## Re: Transport Colorado Sub-Area No 2 ISP 2 Response to Third Submission Review Infrastructure Site Plan Application (Submittal #4)

Number: DA-1793-21  
Case Numbers: 2023-6019-00

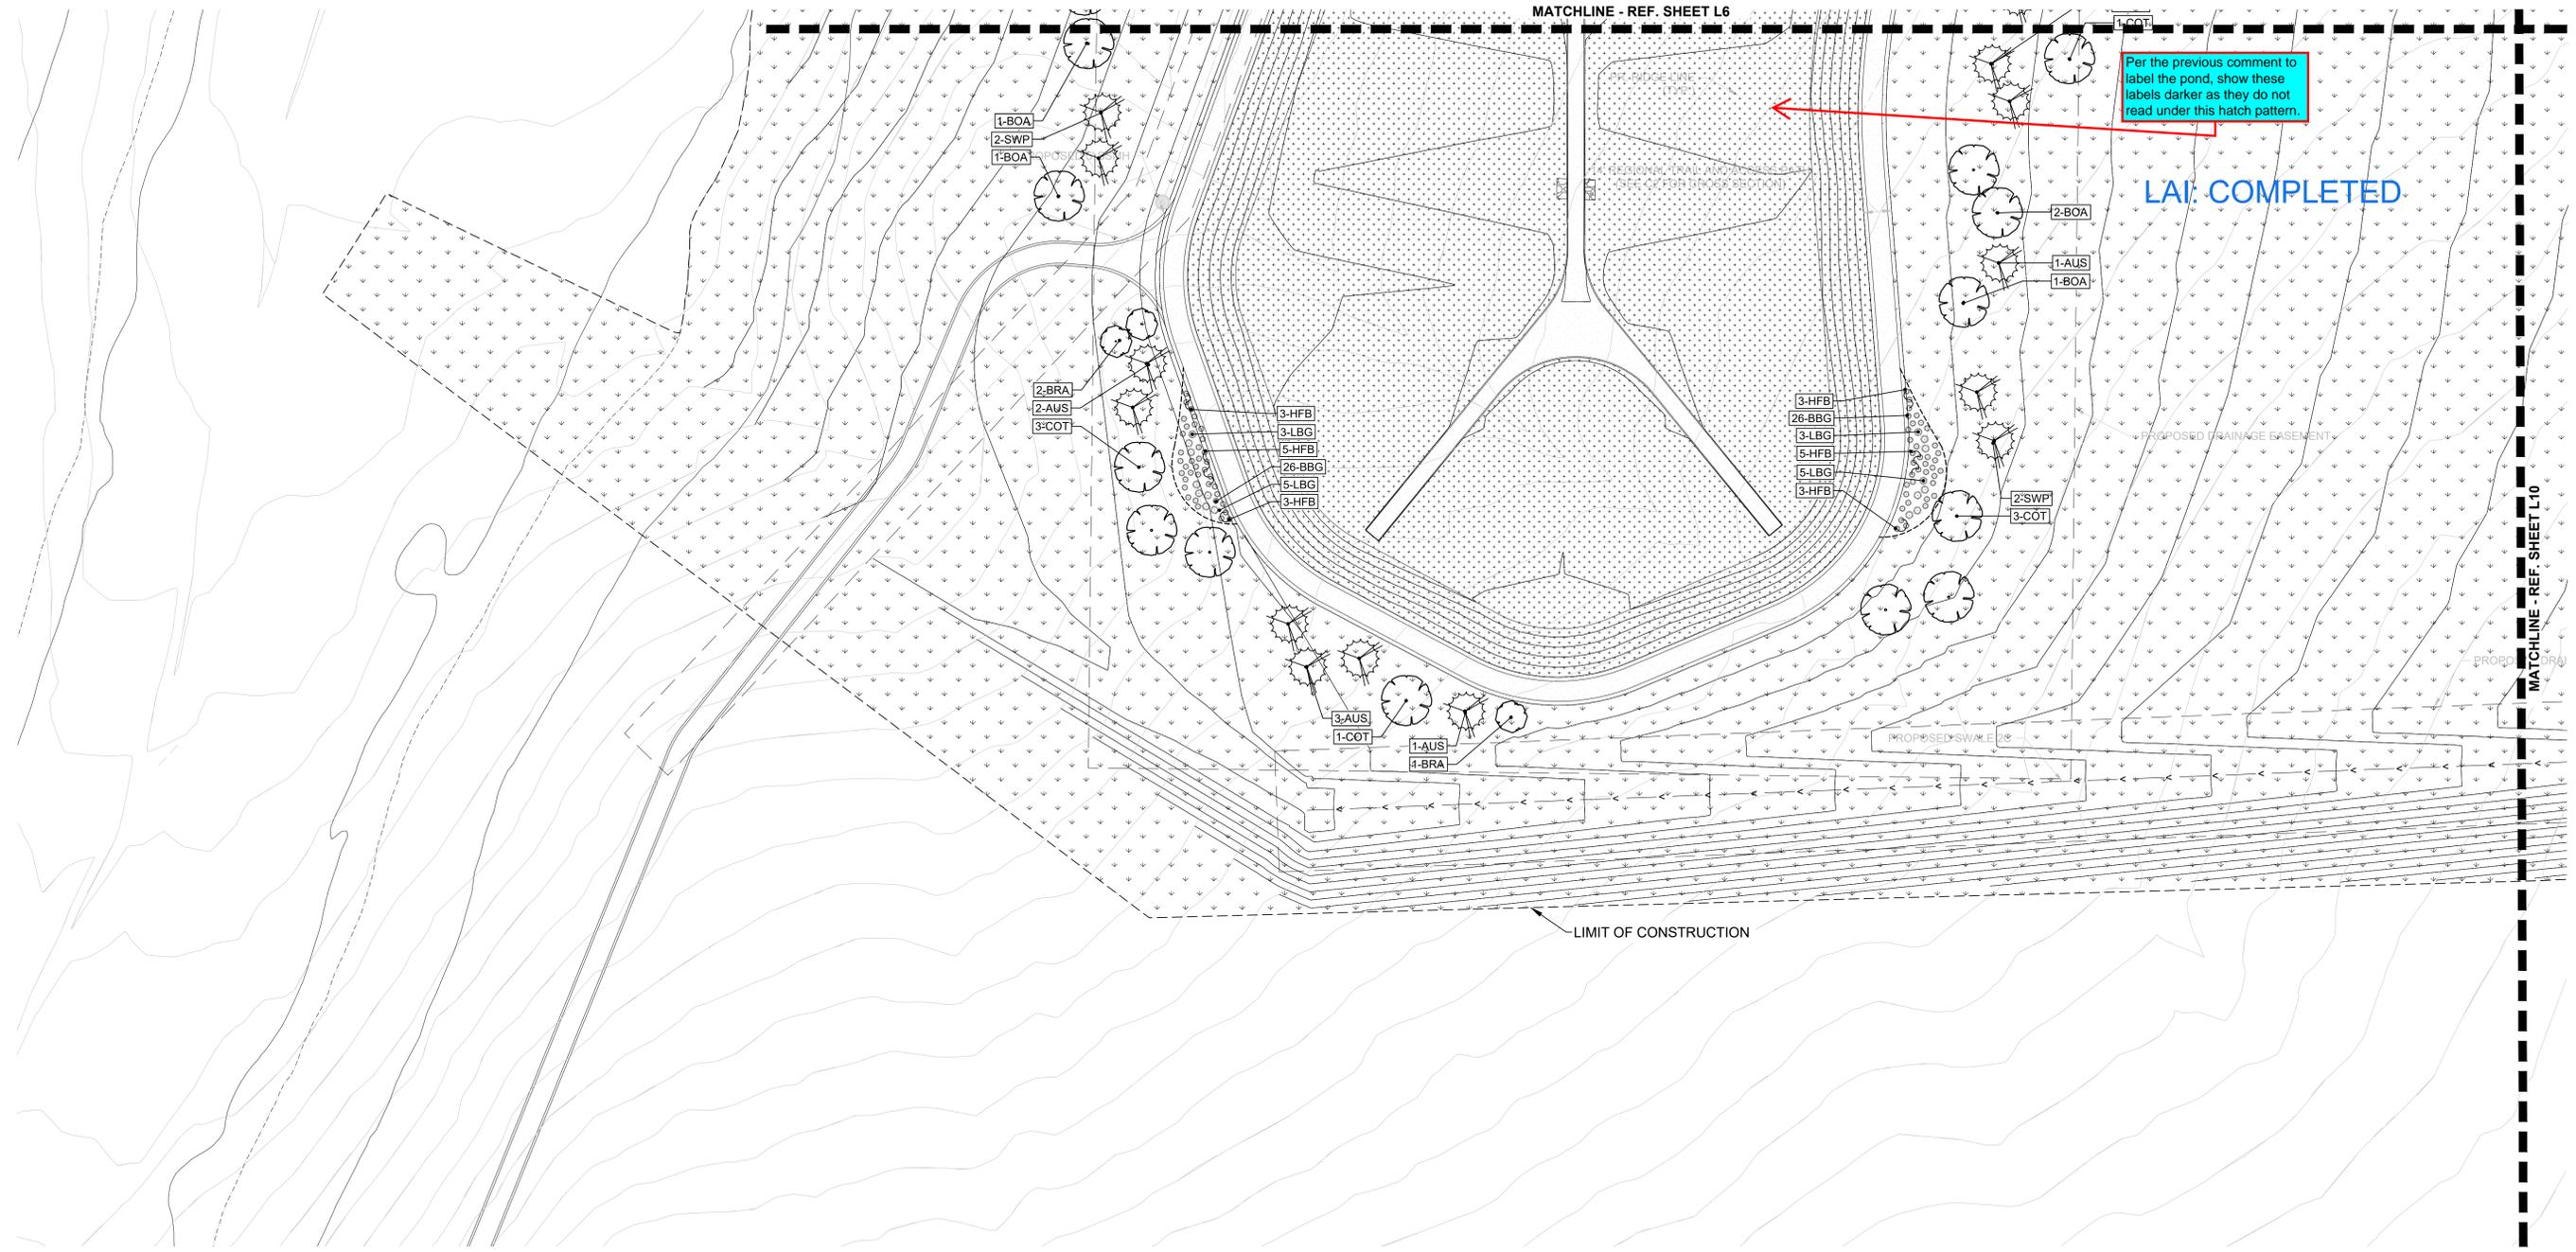
Per the previous comment to label the pond, show these labels darker as they do not read under this hatch pattern.

LAI: COMPLETED
